DeKalb County Department of Planning & Sustainability

STAFF ANALYSIS

Case No.: Z-22-1245935 **Agenda #:** D2

Request: To rezone properties from R-75 (Residential-Medium Lot-75) to RSM (Small Lot Residential Mix) District to construct single-family detached homes.

CONCEPT PLAN 10-17-2022

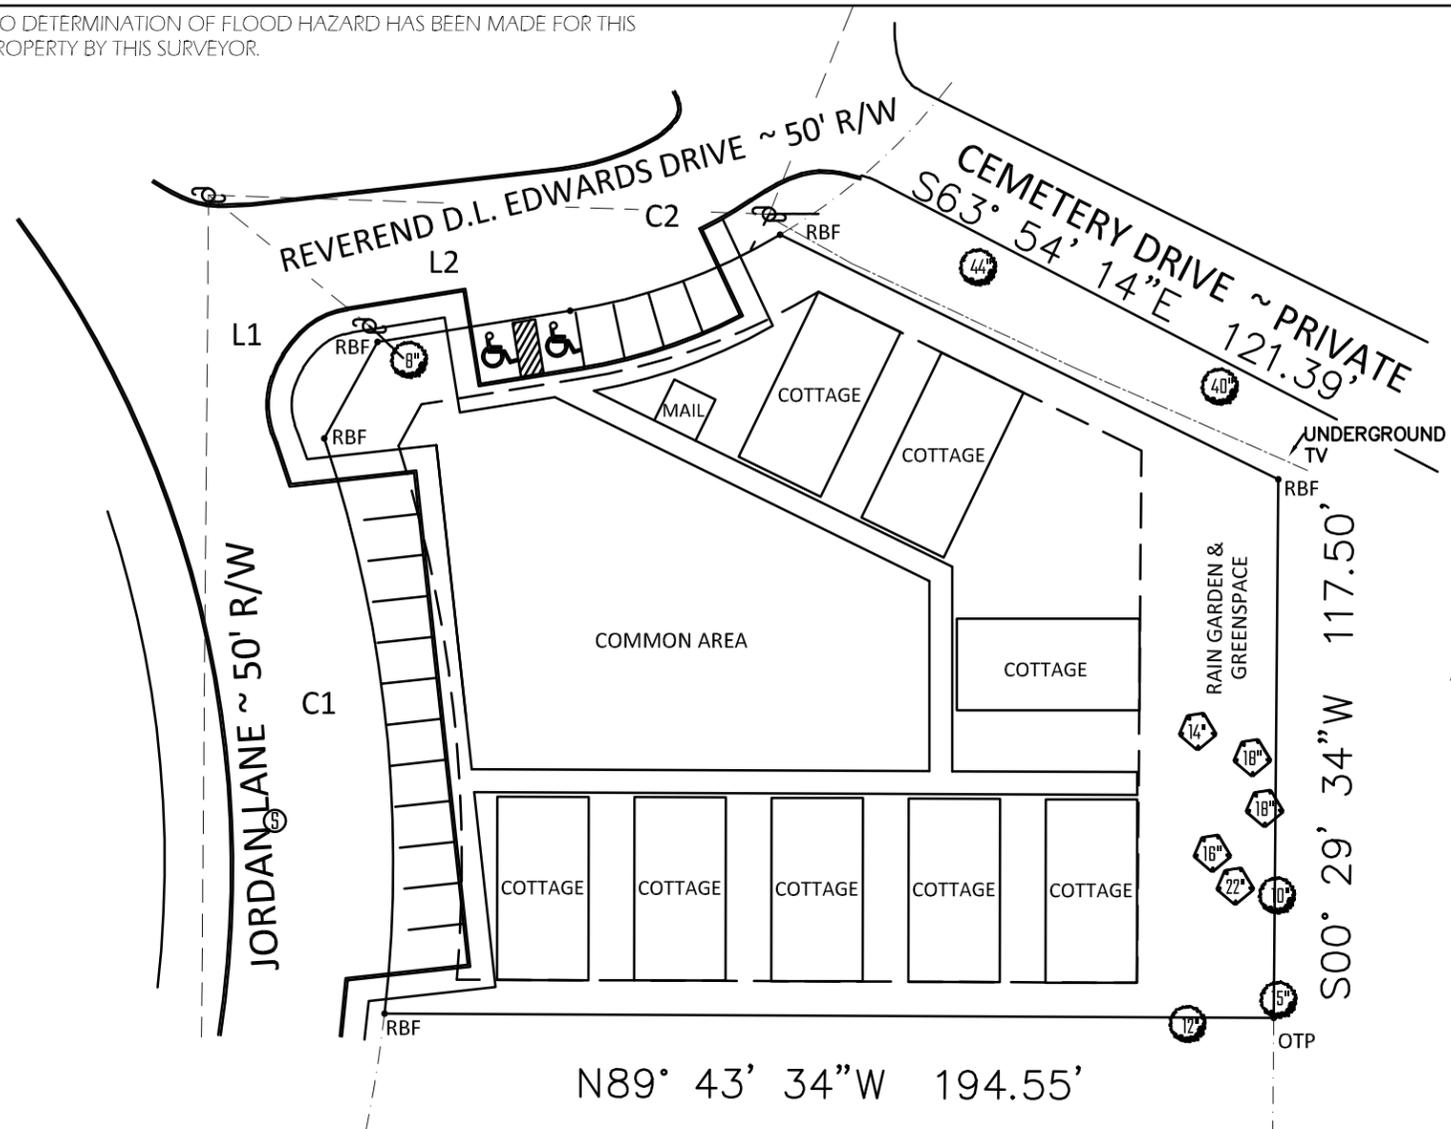
The Applicant submitted a revised concept plan increasing the number of residential units from three single-family detached lots to 8 single-family cottages on 10/18/22 (see attached). Since this major modification was received after publication of the November legal ad, it must be deferred full cycle based on Section 7.2.2.B (3-5) of the Zoning Ordinance as follows:

Please see the lot revision attached -- This would be for single detach cottages with a 800 sft building footprint and 1200 max sft .. 3/2 configurations ...

Conceptual plan doesn't indicate the location of the stormwater management facility. Documents provided show that water quality is being provided for each lot individually, however this development is considered as a subdivision and must comply with all the requirements of the stormwater management, not only water quality. Per sec.5.6.2 of the County codes, the detention facility must be on its own lot.

I recommend the rezoning be denied until a conceptual plan showing or explaining how all the requirements of stormwater managements are to be met; and how compliance with sec.5.6.2 is addressed.
